CITY OF FRANKLIN
COMMON COUNCIL MEETING*
FRANKLIN CITY HALL – COMMON COUNCIL CHAMBERS
9229 WEST LOOMIS ROAD, FRANKLIN, WISCONSIN
AGENDA
TUESDAY SEPTEMBER 2, 2025 AT 6:30 P.M.

1. A Resolution imposing conditions and restrictions for the approval of a Conditional Use for the Franklin High School, an educational facility use, upon property located at 8222 S. 51st Street (TKN 807-9999-001) (Franklin Public Schools, Applicant).

REPORT TO THE PLAN COMMISSION

Conditional Use, Natural Resource Special Exception and Site Plan Amendment

CONSTRUCTION DOCUMENTS
BP1 - 1AM CITY SUBMITTAL
06/24/2025
21-0240-420
SHEET NO
C2.0

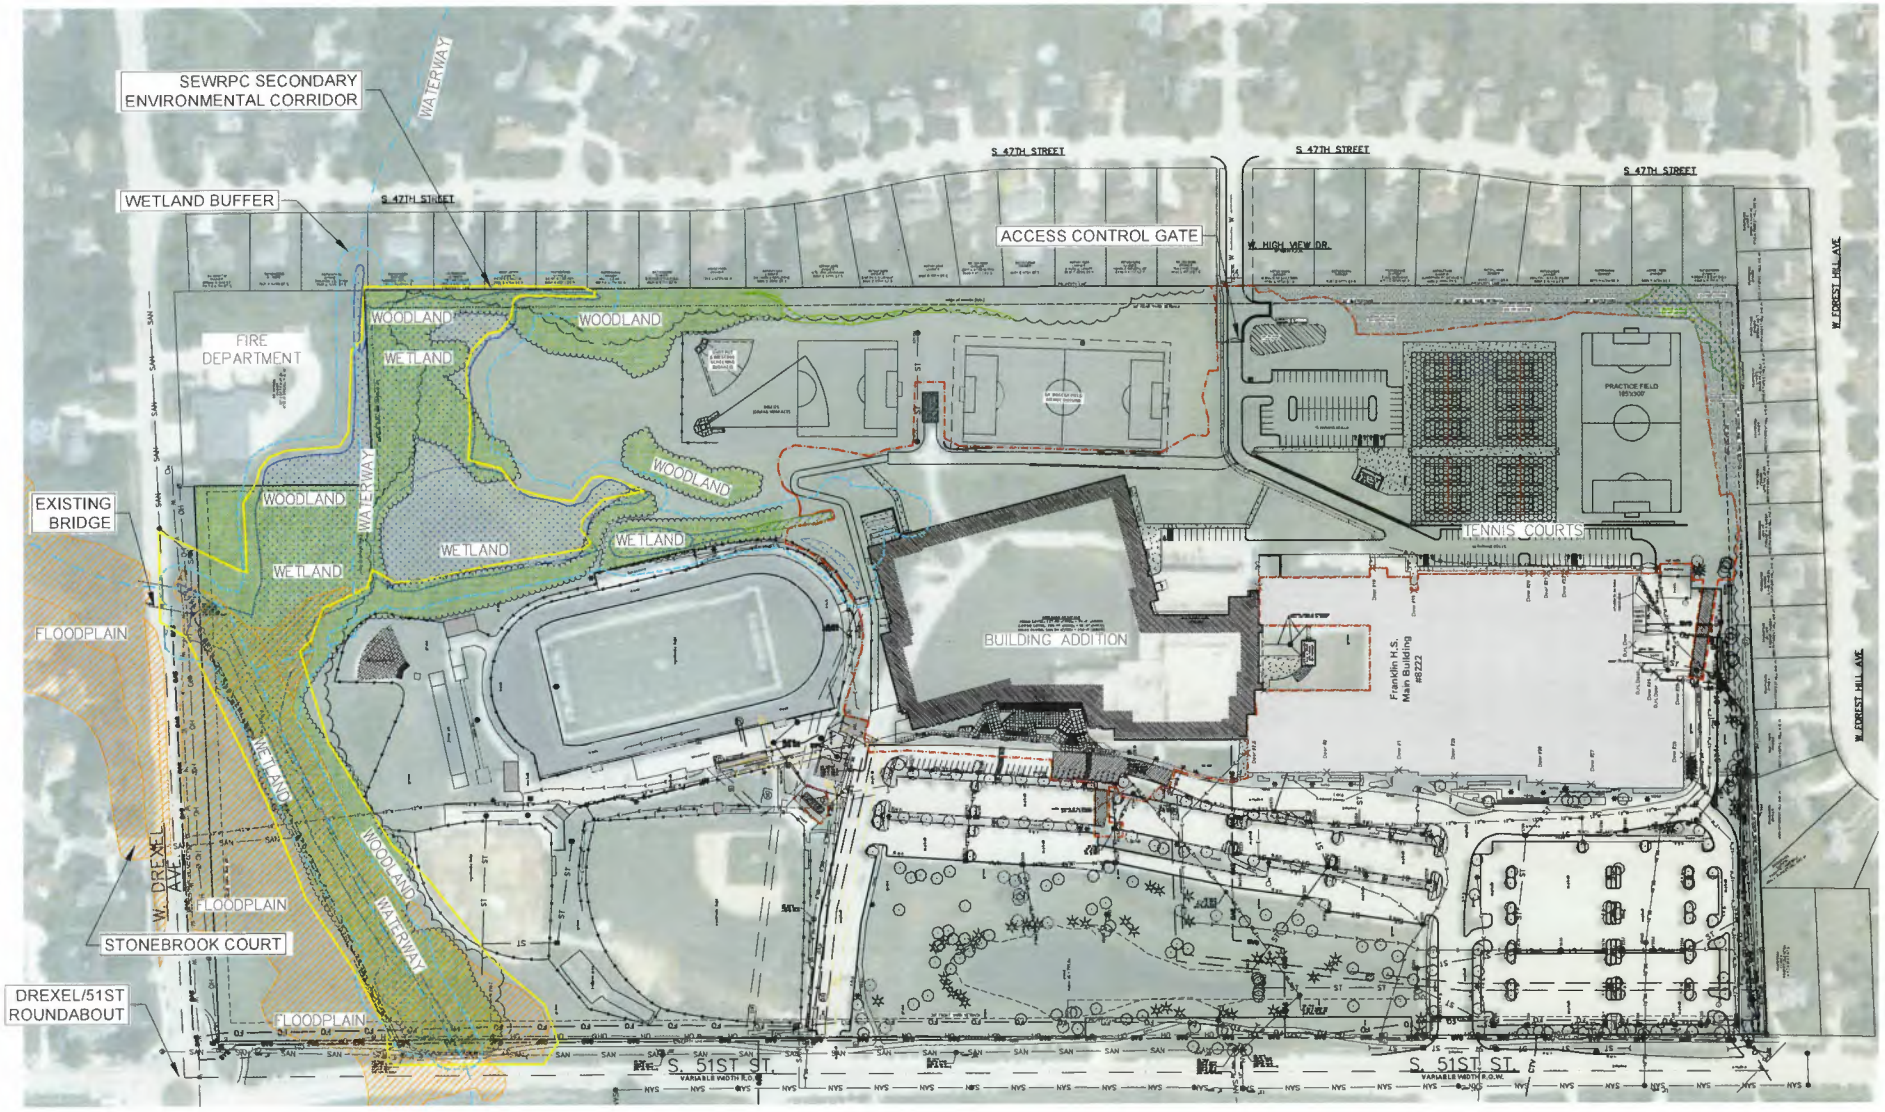
The applicant is requesting the Common Council to revise amendment (1) as the applicant is proposing a gate to restrict access to High View Drive.

1. **Conditional Use Permit**
    a. **Requested Action:** Approval of the Conditional Use Permit with consideration of the proposed site plan allowing vehicle access with the addition of the access-controled vehicular gate at the District property line at High View Drive (in addition to the proposed gate in the south east corner of the existing building). The proposed gate at High View Drive would be access-controlled within the District's security card access / automation system. The district believes they have shown substantial evidence that this successfully balances the concerns regarding uncontrolled site access, while limiting the detrimental operation and programmatic impacts of the alternative Plan Commission action. The district also believes that not allowing access to High View Drive will lead to community members parking on streets to the east and adjacent to the district to gain access to the tennis courts. A traffic study has been considered, however, with controlled access and a very limited number of parking spots on this side of the school, we know the impact is approximately 70 employee vehicles for 15 minutes twice a day and some additional traffic on tennis match days. The district will continue to monitor usage to ensure this is followed.

b. **Additional Considerations:**
        i. Environmental Impact Analysis: Per discussion at the City of Franklin - Plan Commission regarding an alternative access drive, please see the attached exhibit comparing environmental impacts. This matrix document aims to objectively compare two scenarios:

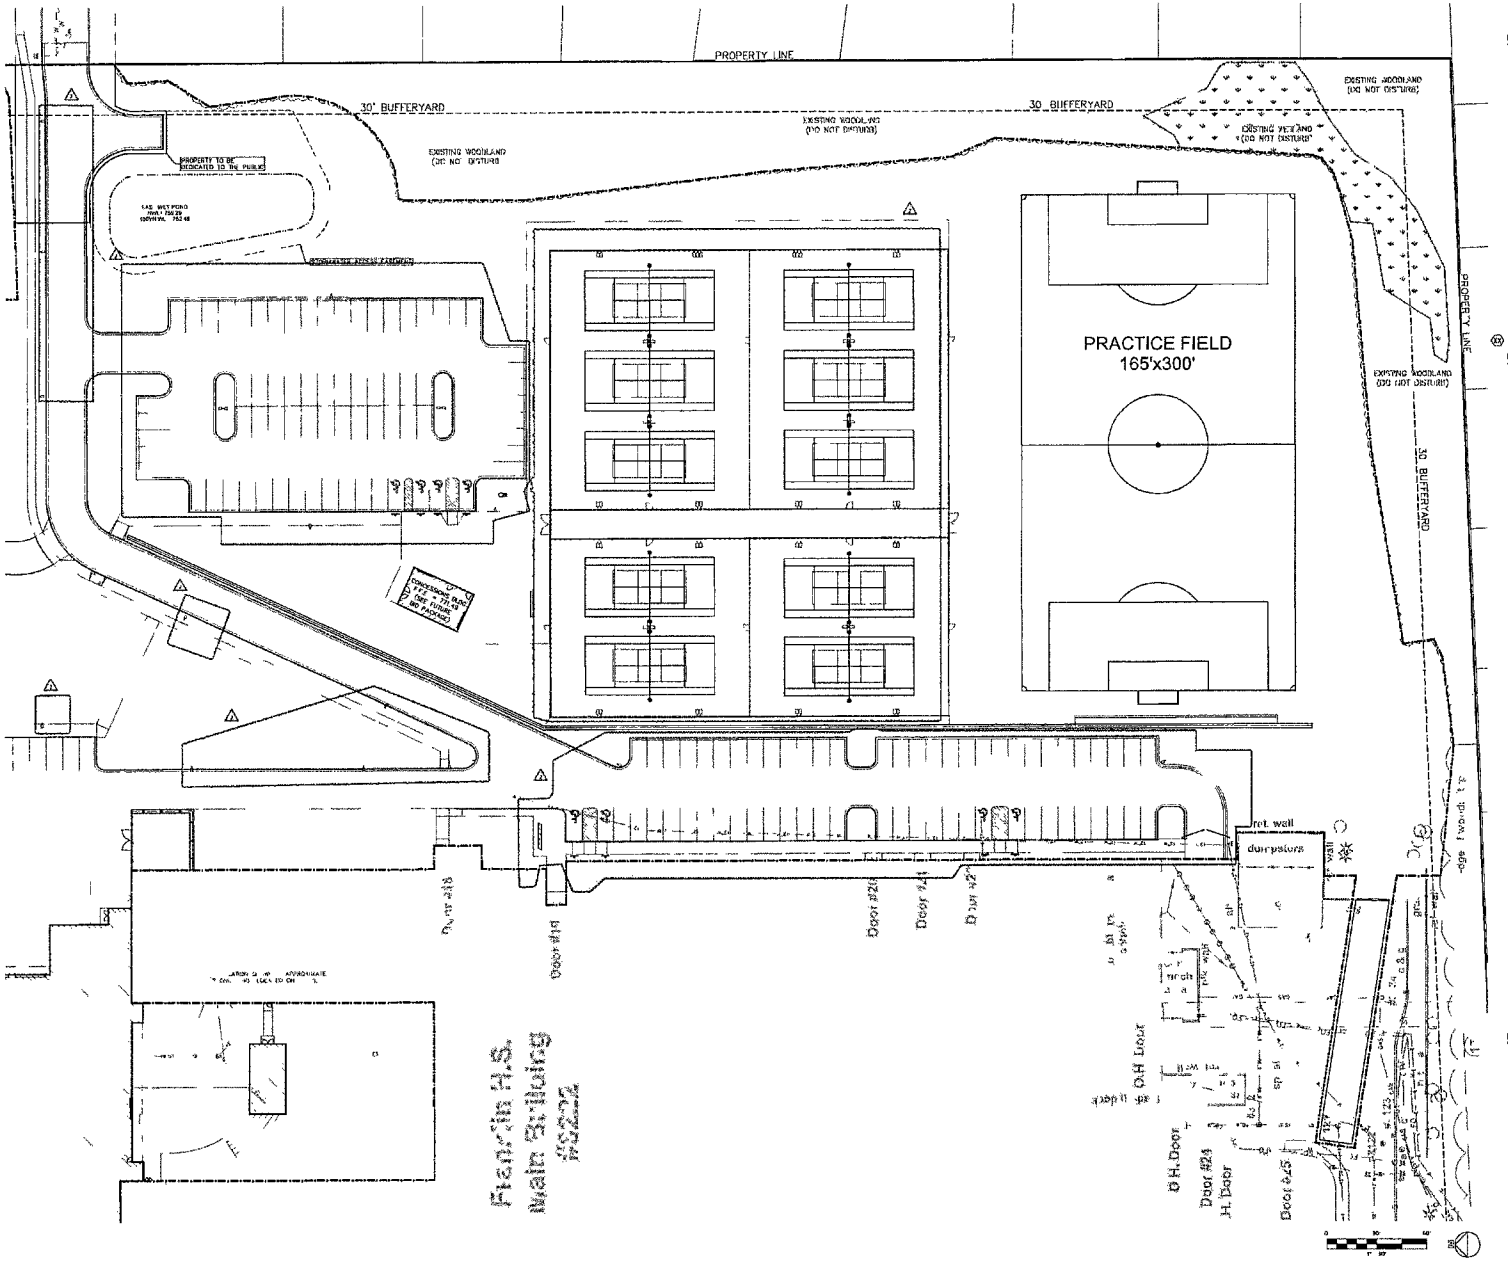
9. Sheet C2.0 indicates 116 new parking spaces between the existing and proposed, but 147 new parking spaces are being provided. Is existing parking being eliminated elsewhere onsite? Yes, there are existing parking spaces that conflict with the proposed building addition that are being eliminated north and east of the existing facility.

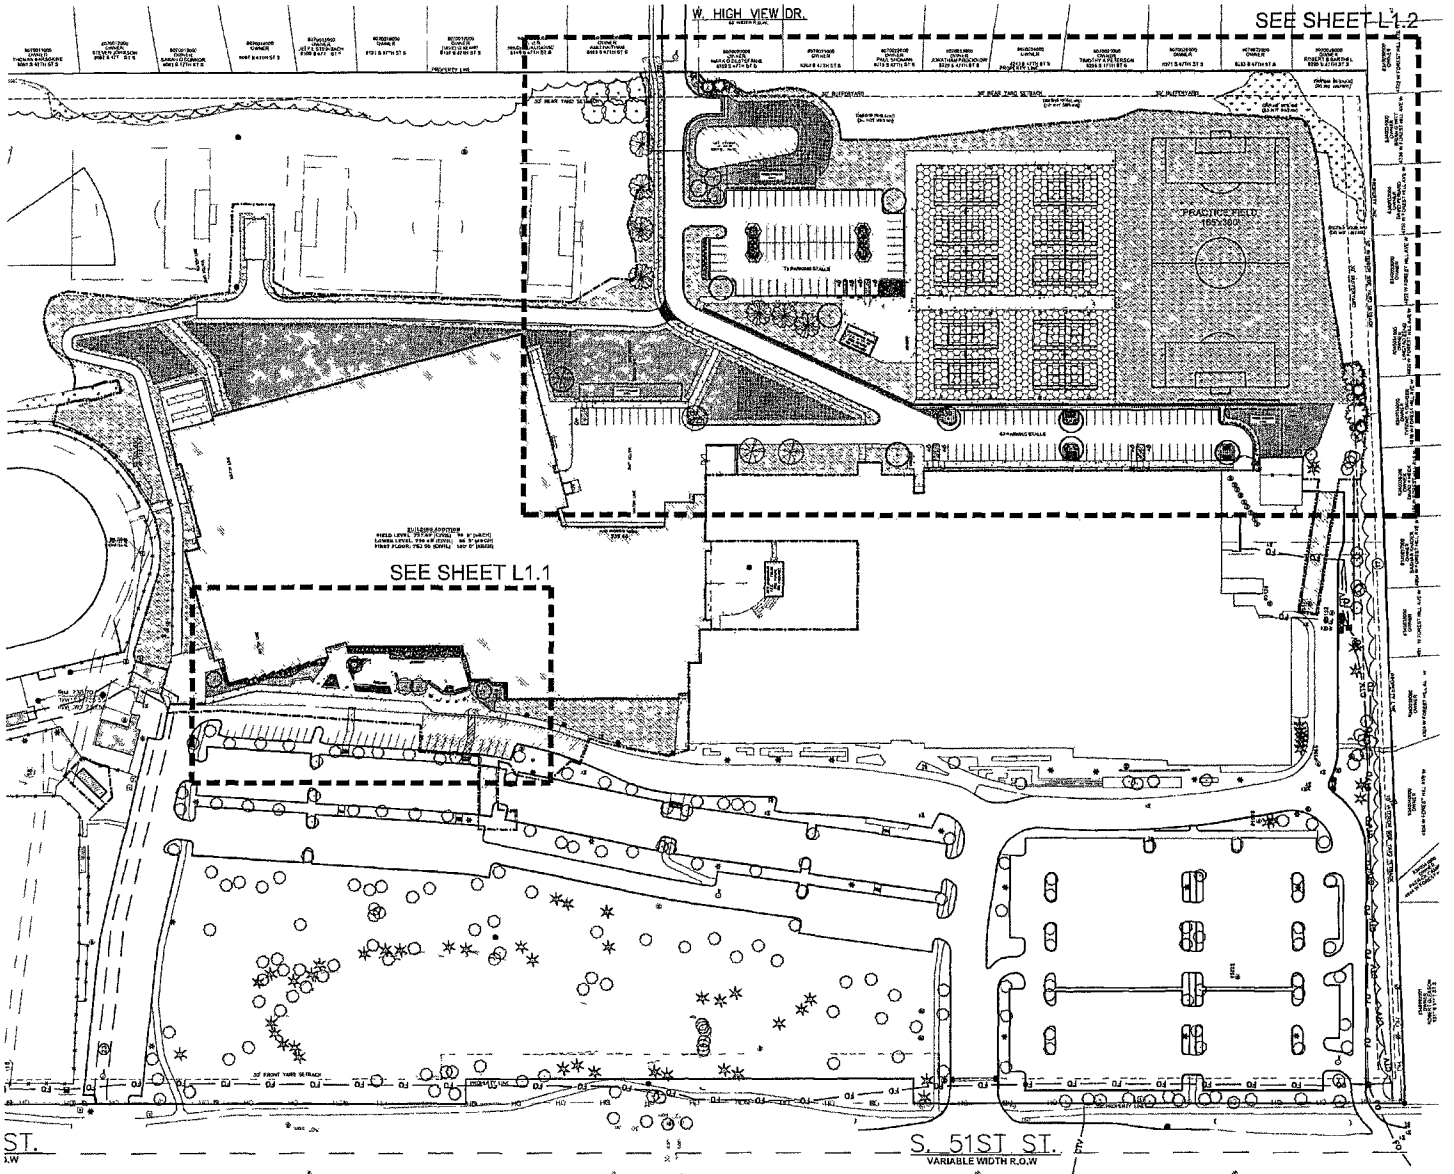
5. Please revise required planting quantities to include a 20% increase as required by Section 15-5-04C. of the UDO. The proposed planting quantities include the required 20% increase. See sheet L1.2, landscape requirements, "Bufferyard Requirement".
